## GENERAL INFORMATION

Applicant:	Bloomington Central Station LLC c/o McGough Development
Location:	8170 31 <sup>st</sup> Avenue South
Request:	Preliminary and Final Plat for Bloomington Central Station 5 <sup>th</sup> Addition; Major Revision to Final Development Plan for a 1,657 stall parking structure and surface parking improvements.
Existing Land Use and Zoning:	Vacant commercial land; zoned High Intensity Mixed Use with Residential (Planned Development) – HX-R (PD) and Airport Runway – AR-17
Surrounding Land Use and Zoning:	North – Park, surface parking and light rail transit right-of-way; zoned HX-R (PD) South – Office and vacant land; zoned C-4 East – Multiple-family dwelling; zoned HX-R (PD) West – Structure parking ramp, office and manufacturing; zoned LX and CO-1
Comprehensive Plan Designation:	South Loop Mixed Use

## **PROPOSAL**

### **Exhibit 1: Parking Areas for BCS – Health Partners**

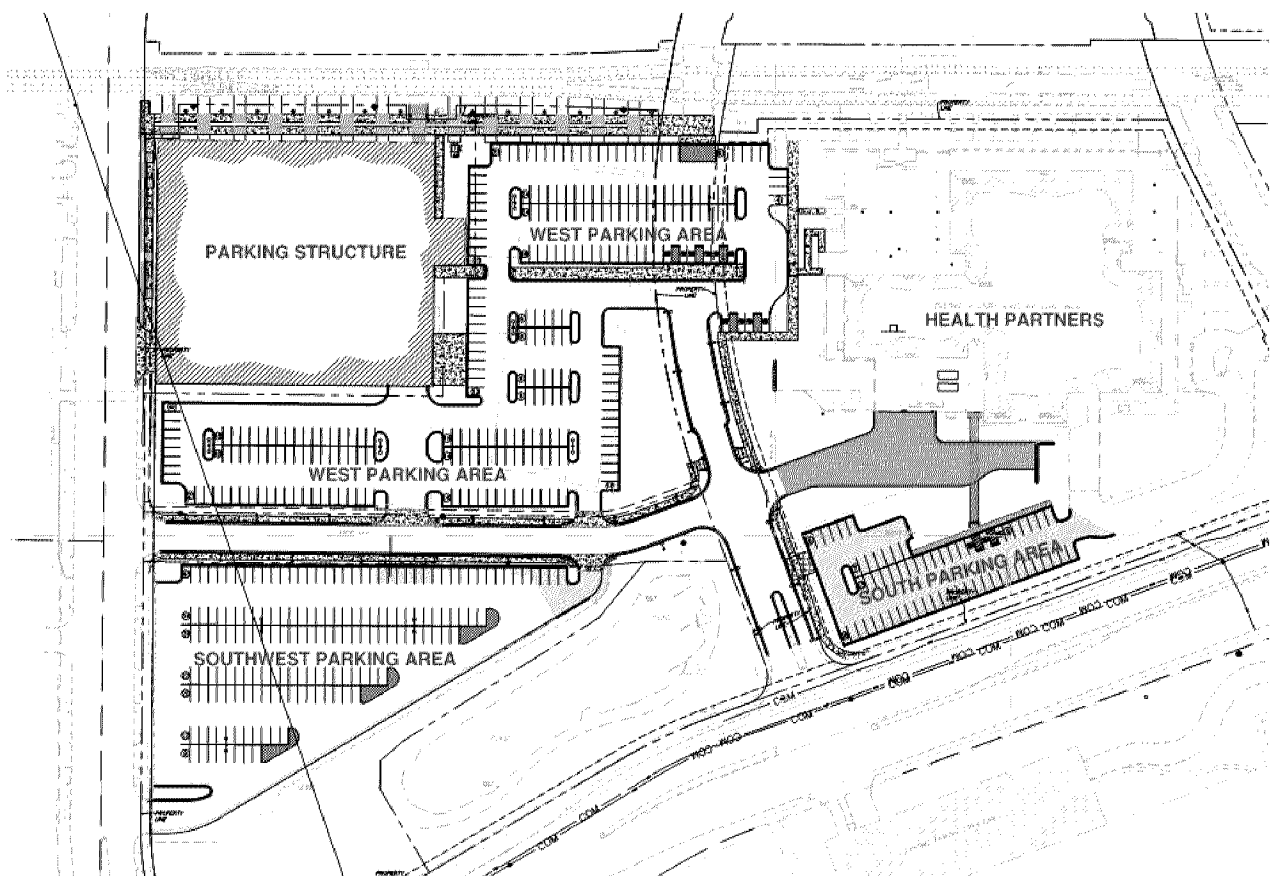
Along with the parking structure, there are three areas of surface parking proposed. See Exhibit 1 for a map identifying the surface parking areas discussed in this report. Each specific surface parking area is proposed to be modified in some fashion from its existing condition.

In addition to parking counts, a summary of improvements to the three surface parking areas is also warranted. Code-compliant landscaping and lighting is planned for both the South and West parking areas, whereas only Code-compliant lighting is planned for the Southwest parking area. The improvements to the Southwest parking area are considered to be more related to parking lot maintenance than permanent development. The temporary parking lots were approved to be constructed in their current condition while awaiting future development. All of the surface parking areas are intended for more permanent development at some point in the future. Nevertheless, the West and South parking areas will be improved to Code-compliant status for the interim period prior to future development.
